Re: Second Submission Review: Green Valley Ranch East – Site Plan No. 19, Plat Vacation and Plat
Application Number: DA-1662-35
Case Numbers: 2021-4010-01; 2021-3017-01; 2024-3030-00

Second Submission Review

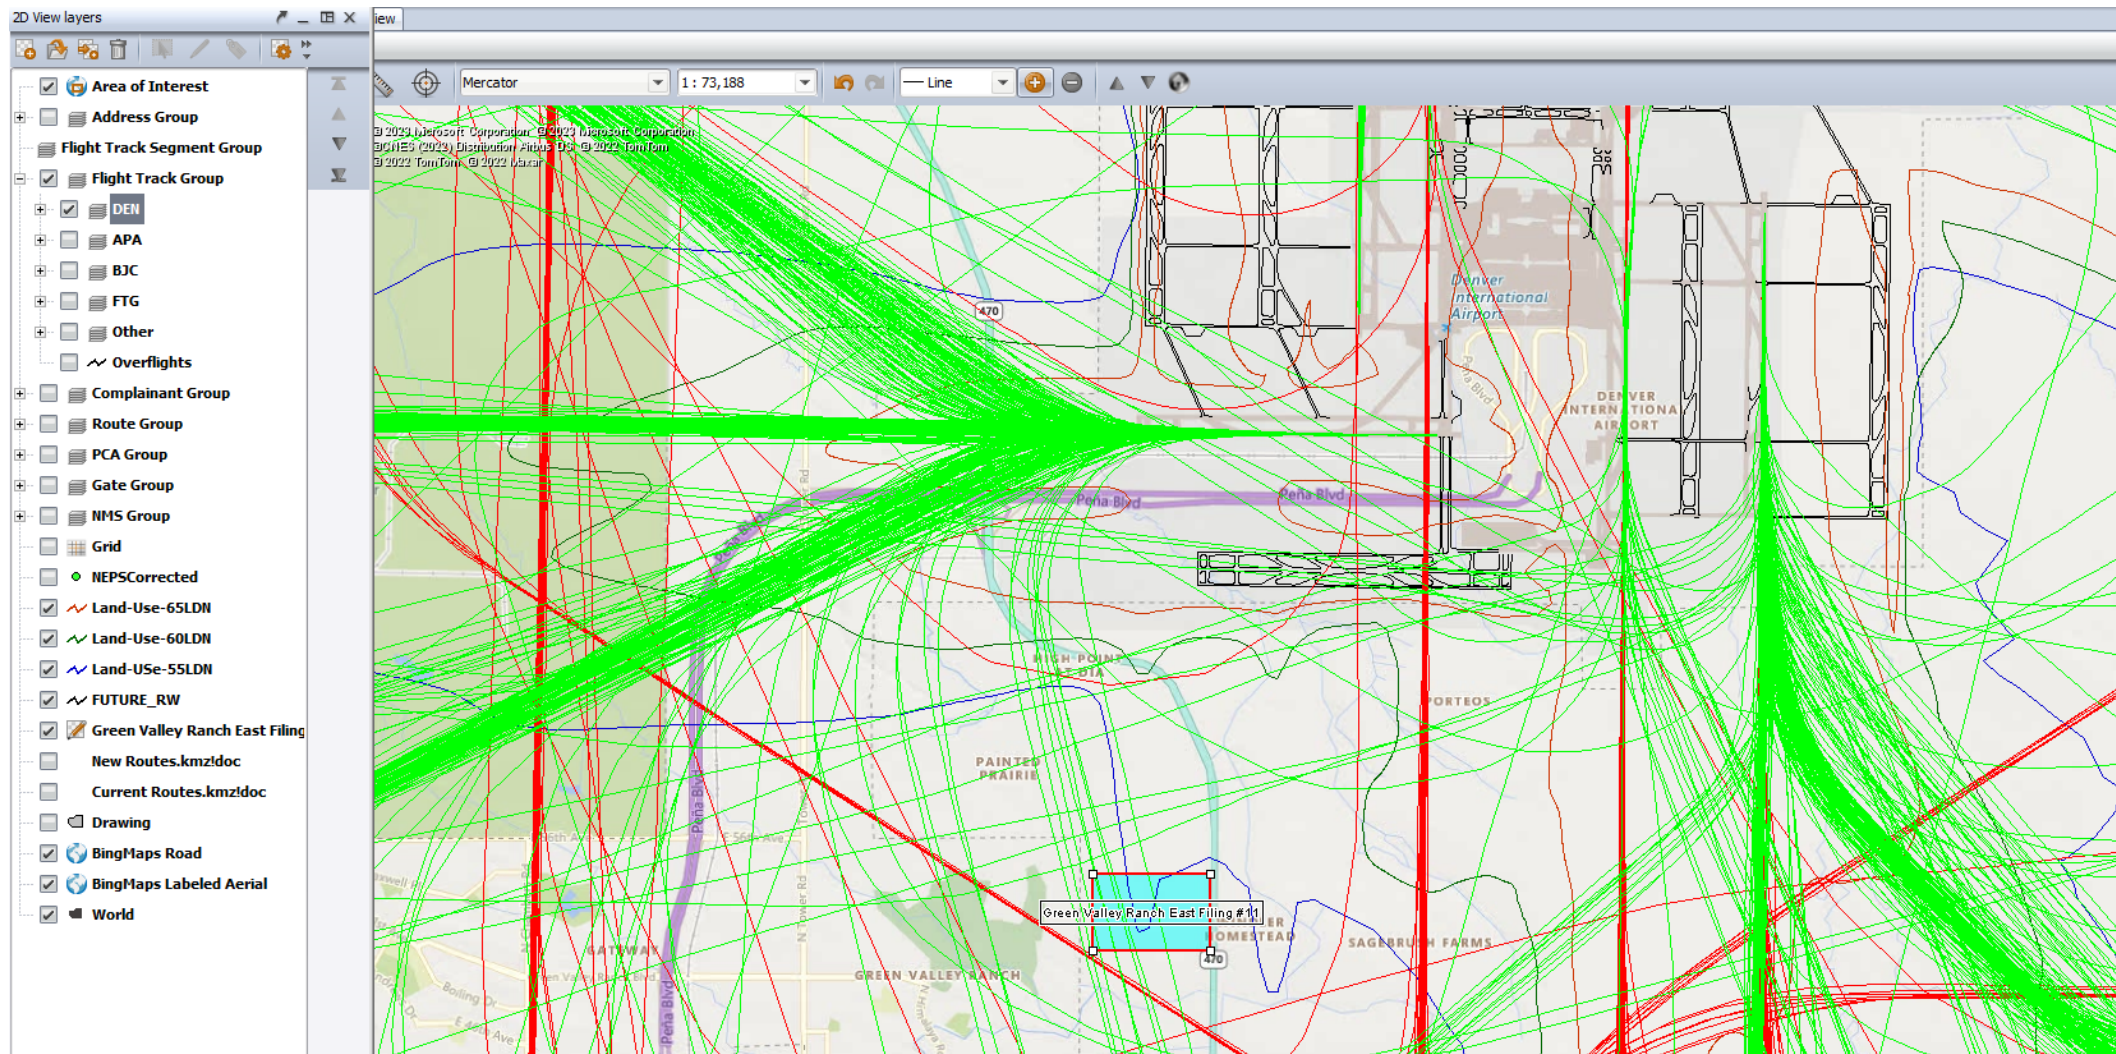
This property will be subject to overflights to and from Denver International Airport (DEN). Included are flight track maps showing the different flight track pattern scenarios and their altitudes related to the arrivals and departures at DEN. All related aviation noise statements should be included in any information sharing, documentation and contracts.

Other developments in this area have been reviewed previously, and the noise analysis still holds true. While this area is not currently under an arrival pattern, the future north-south runways on the west side of the airfield will put arrivals over the subject property. This portion of the development could potentially have arrival overflights from the south at altitudes of between 1,500 feet above ground level (AGL) and 4,100 feet AGL depending on the aircraft type and what arrival runway the Federal Aviation Administration (FAA) air traffic controllers have directed the aircraft to land on. If the winds are out of the north, aircraft will land coming in from the south on final approach to DEN. Aircraft currently arrive to DEN on runways 34L and 34R and with the potential of 4 North/South runways on the West side of the airfield there could be even more daily arrival overflights of this development. The future runways are depicted in black on this map of flight data from 2/28/23. This day's flights depict a typical flight pattern for a 24 period.

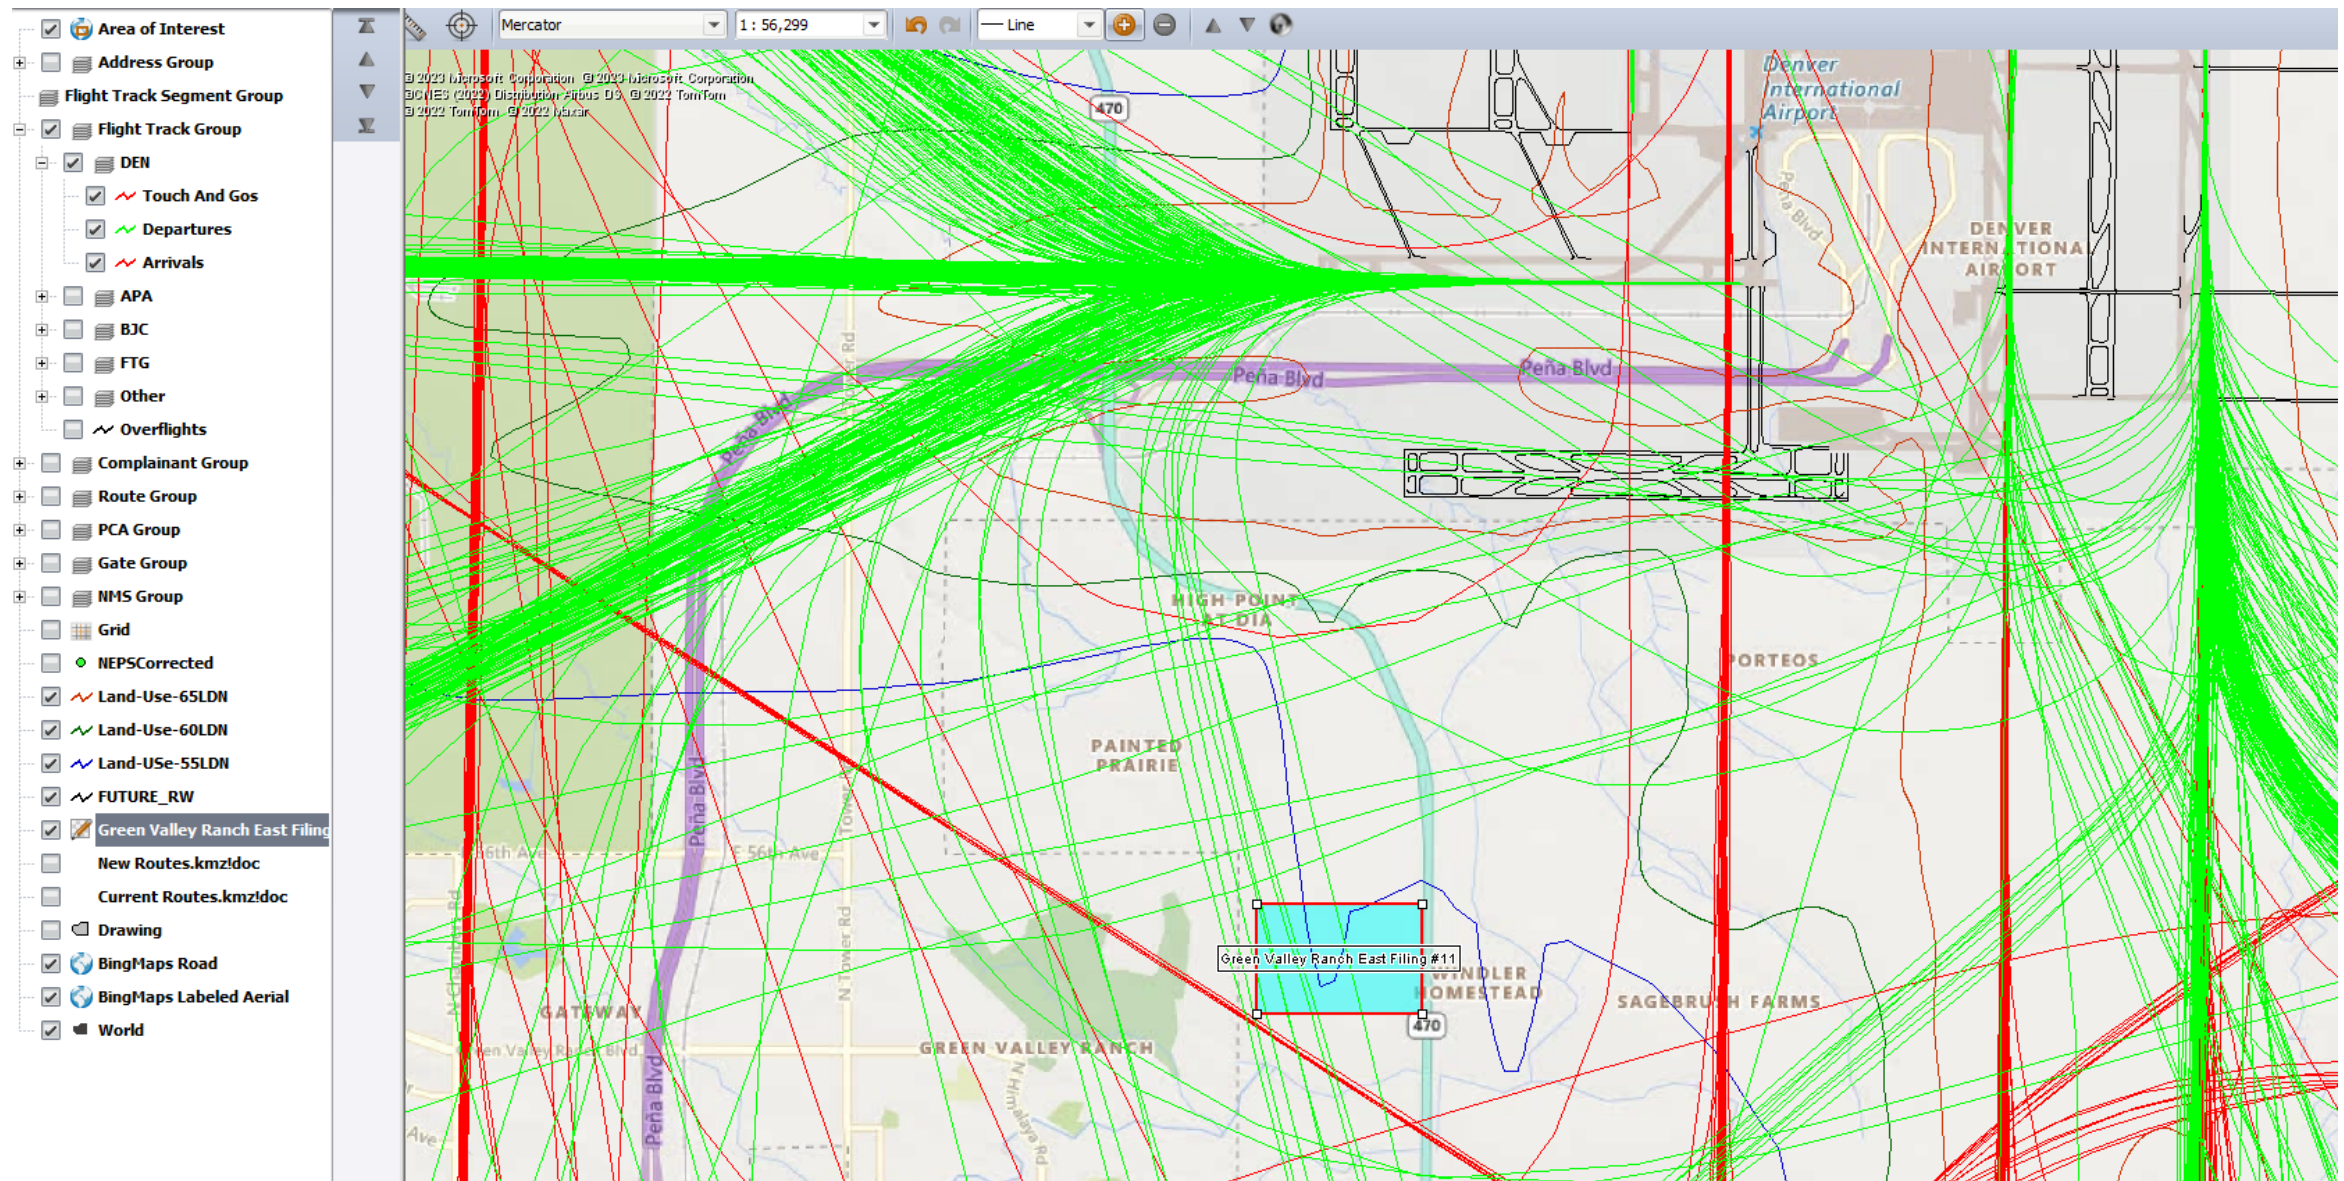
Same flight data from 2/28/23, zoomed in to see the 55, 60 and 65 DNL contour and the property area in light blue. The 55 DNL intersects the property on the north end. This portion of the 55 DNL pertains to the additional 2 potential north/south runways on the west side of the airfield. Once the runway straight north of this property is built, 16C/34C (might be the runway names) there will be overflights at the beforementioned altitudes. There could be upwards of 200+ arrivals per day to those future runways.
